EPC STORMWATER REVIEW COMMENTS IN ORANGE BOXES WITH BLACK TEXT

3255 HAY CREEK ROAD

GRADING & EROSION CONTROL PLAN

COUNTY PCD NO: CDR2611

INITIAL-FINAL GEC PLAN

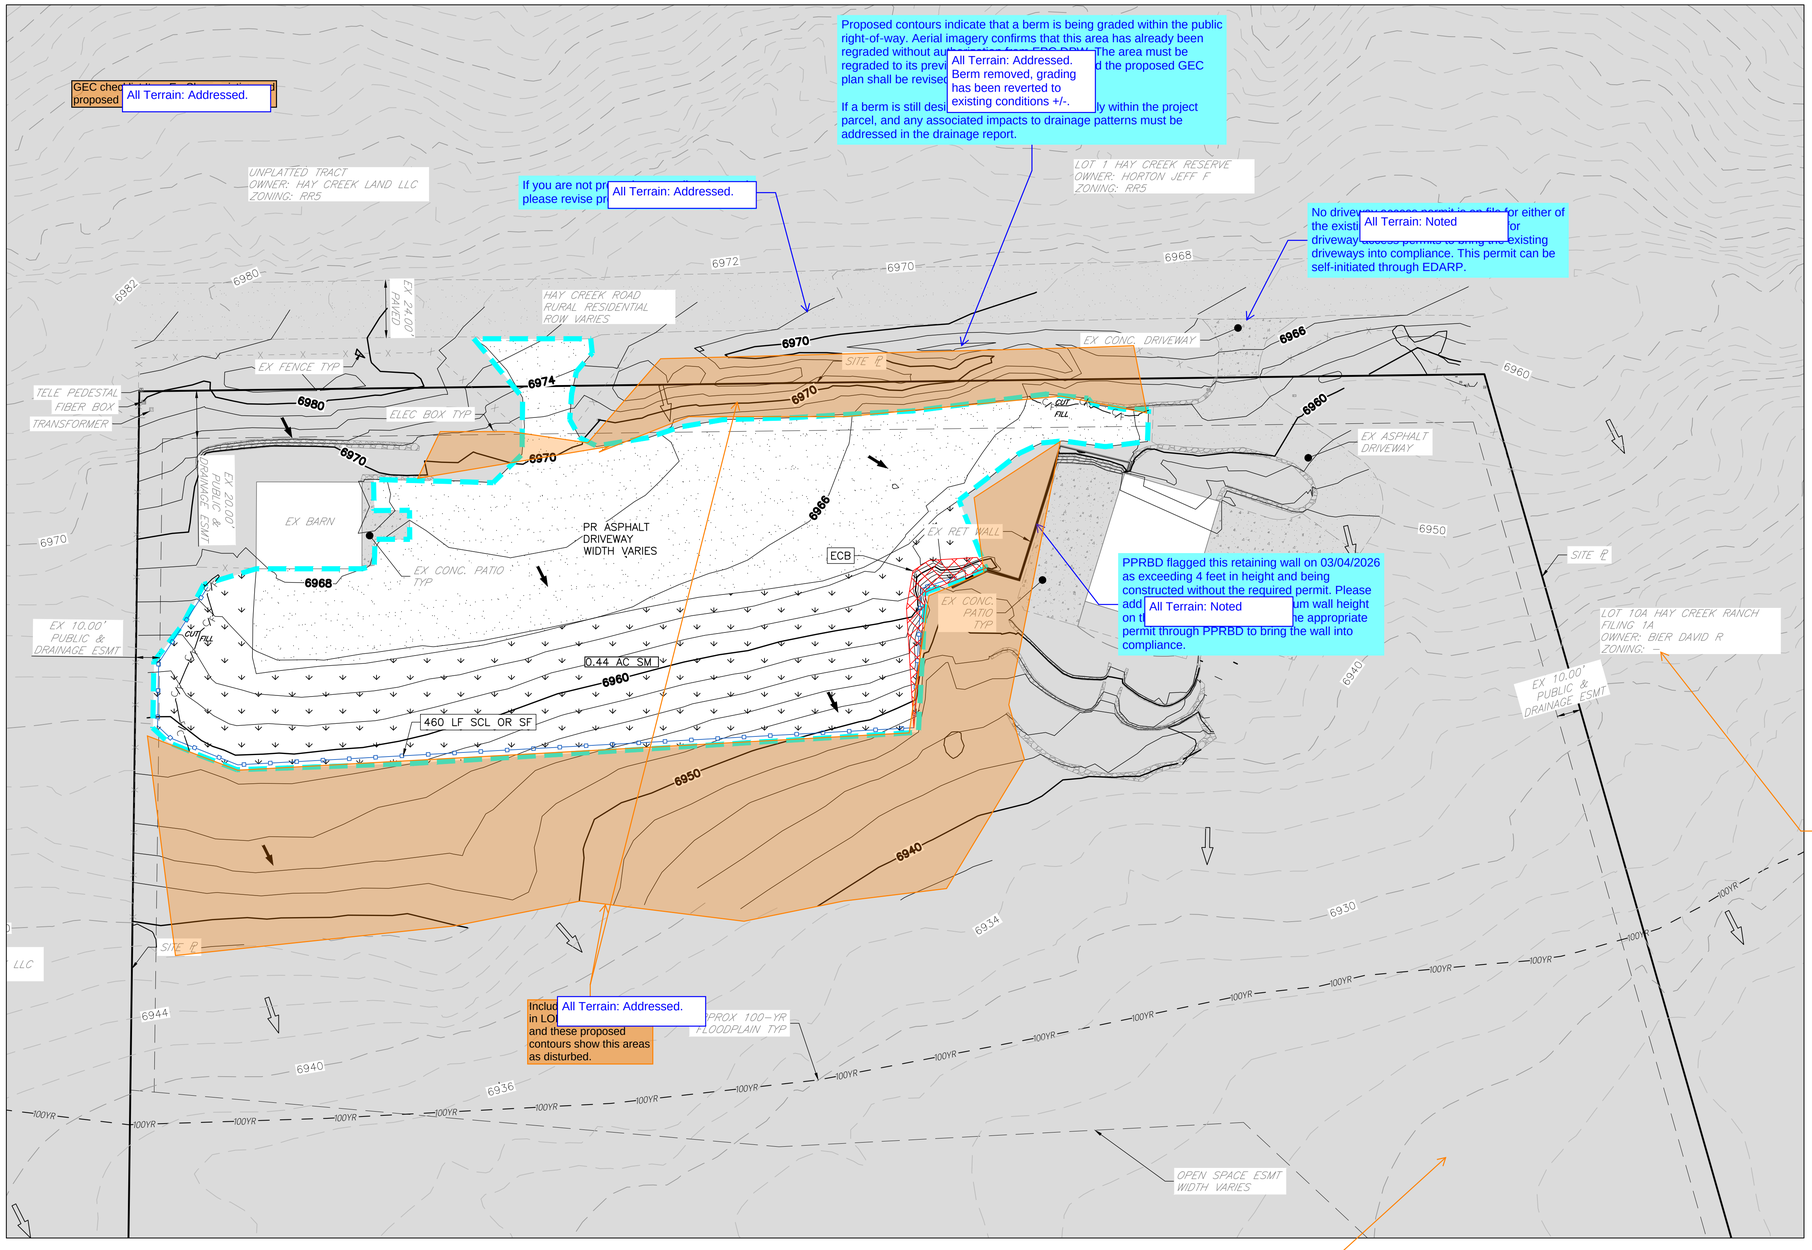
GEC Checklist Item shall be identified t implementation to and "final".
All Terrain: Addressed. See notes.

The limits of disturbance should include the full dist and
All Terrain: Addressed.

A s all not following the purpose of the proposed contours if they are not new disturbance.
All Terrain: Addressed.

GEC Checklist Item J - include name of streams within or bordering the site. This is Hay Creek, please label.

DETAILS

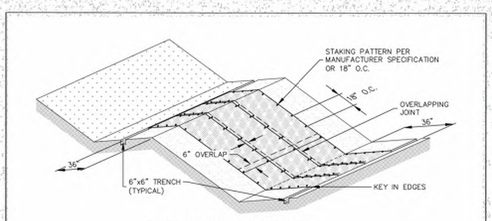
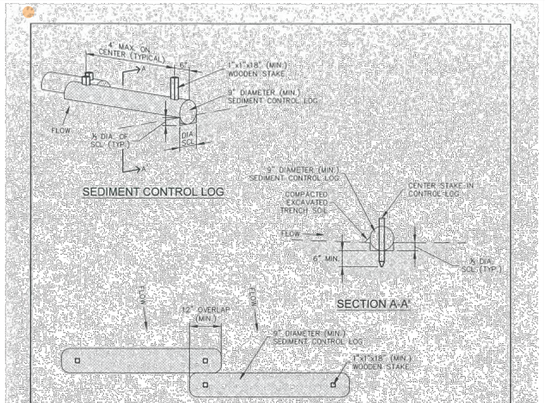
replace with legible details
